Re: Addendum No. 1
Jefferson Wastewater Treatment Plant Clarifier Improvements – Phase 2
Village of Jefferson, OH

Date: August 5, 2026

PLAN-EFFLUENT TROUGH DROP BOX

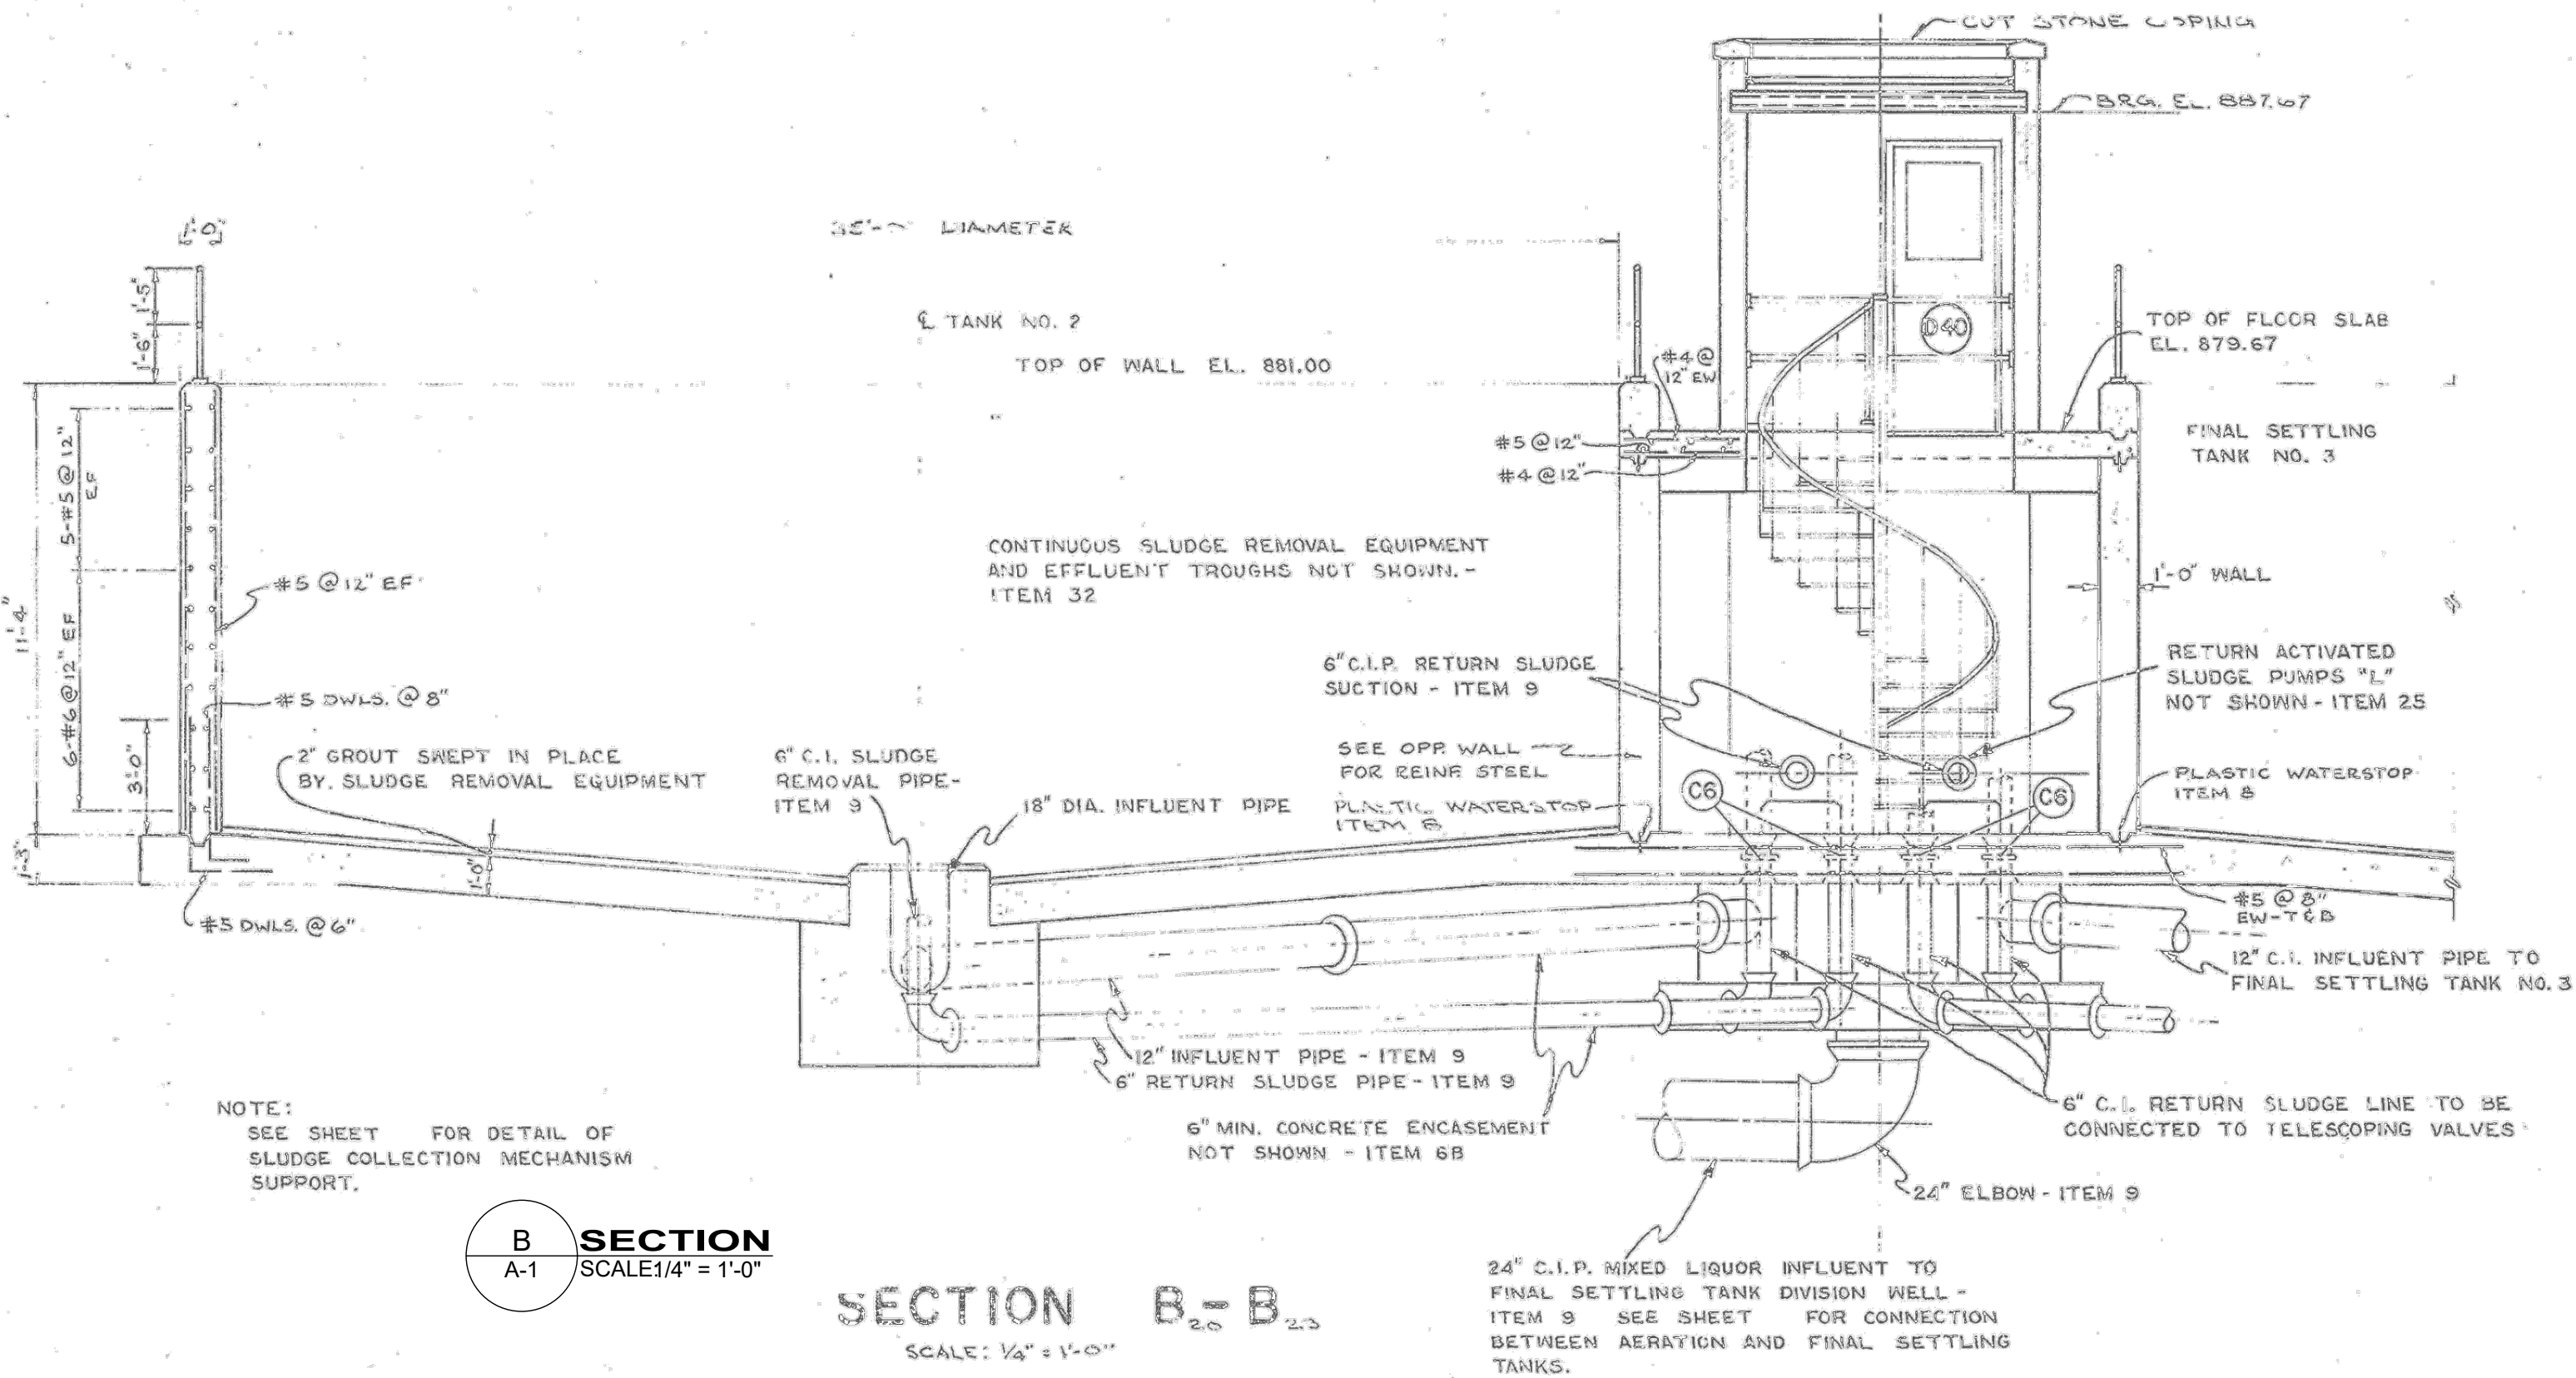
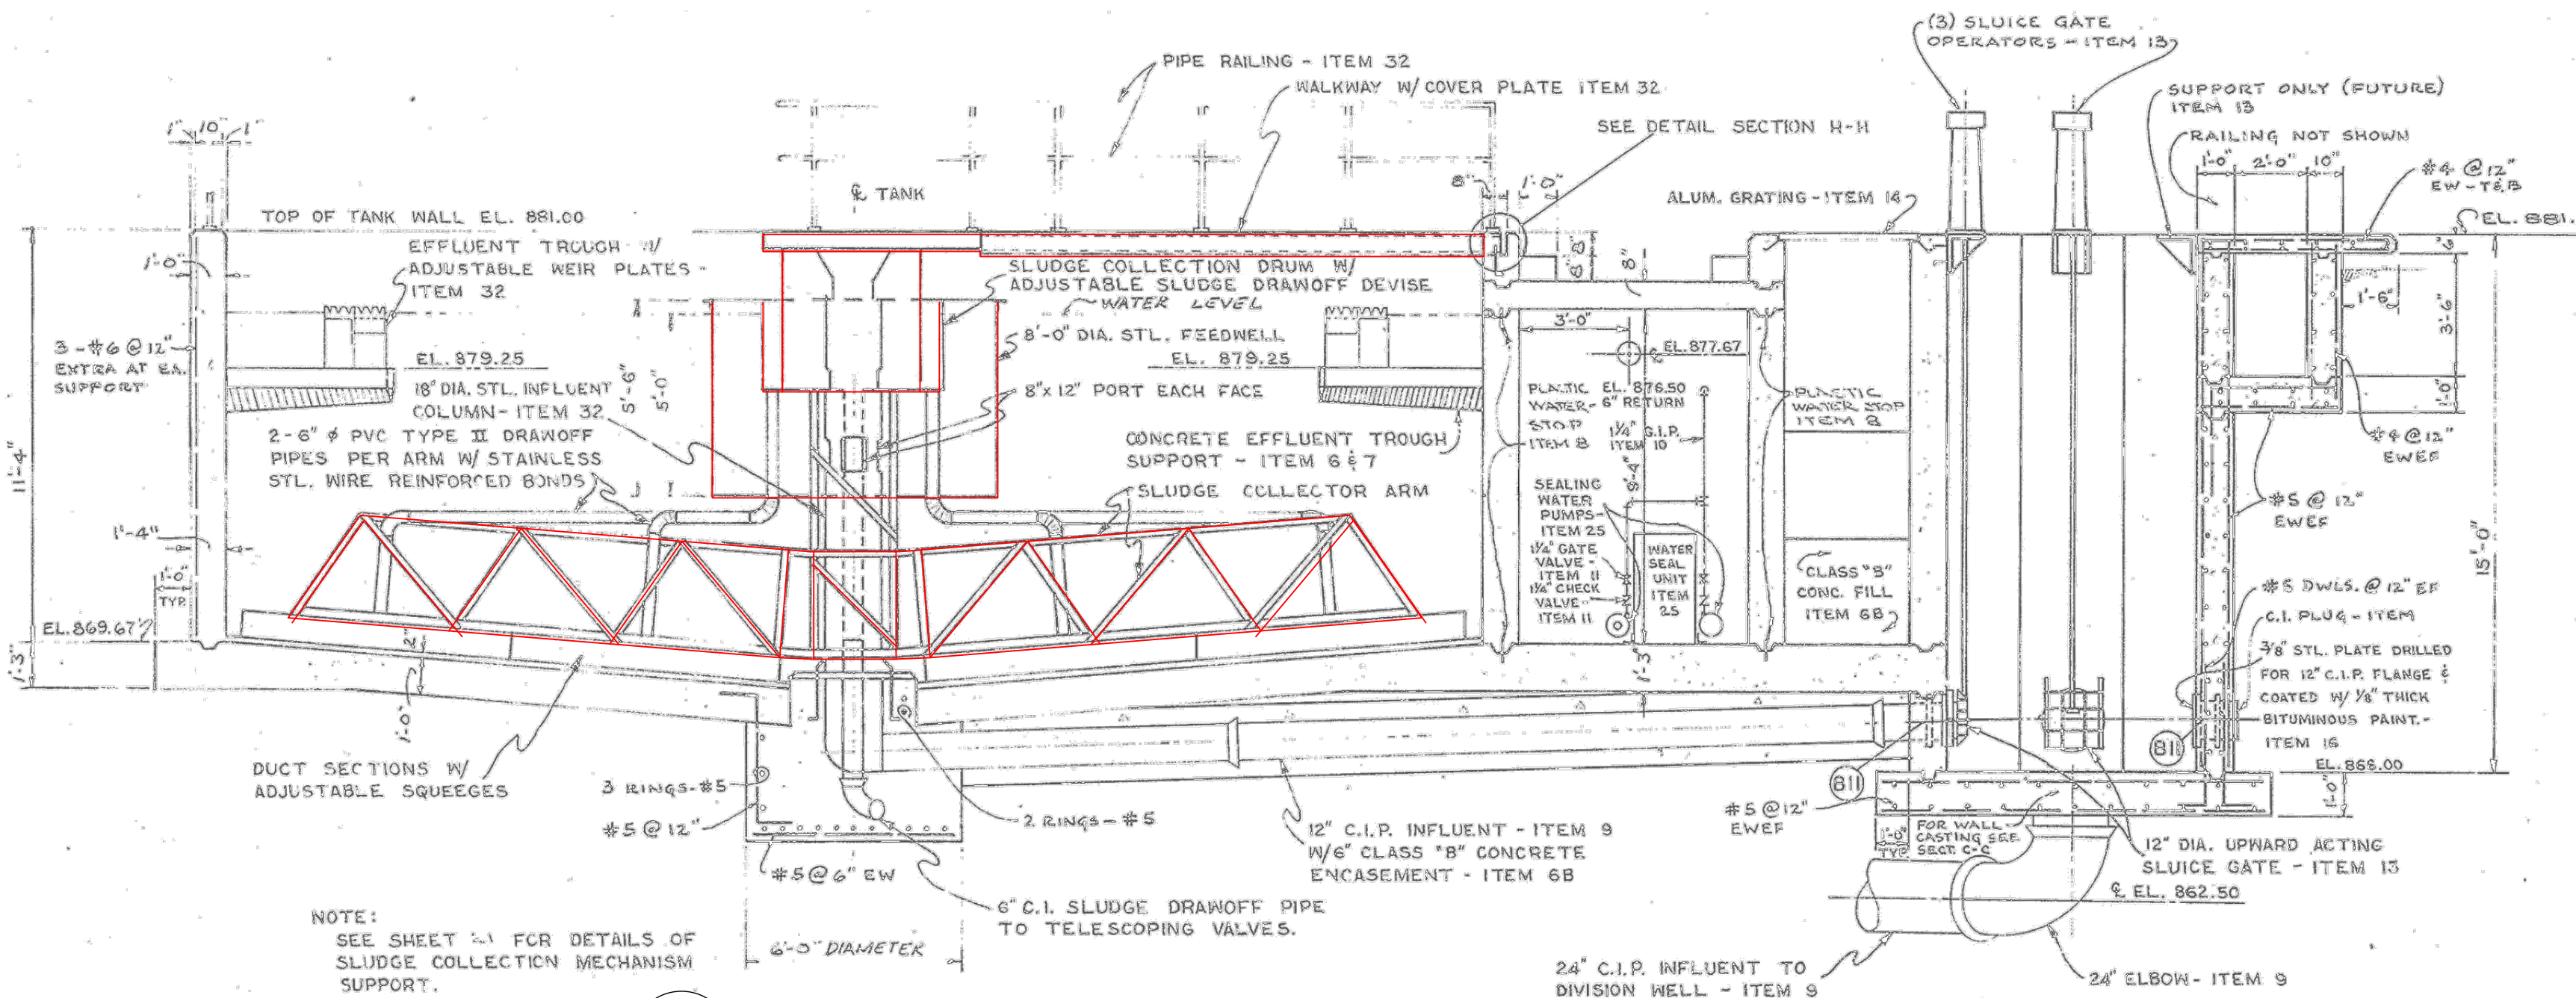
Q2. There is a metal bent plate located underneath the concrete drop-box that is not shown on the drawings? Should we include the removal and replacement of this item in our scope of work?

A2. Yes, plate is to be included in the scope to remove and replace with stainless steel. See attached plan sheet 13 of 15 for details.
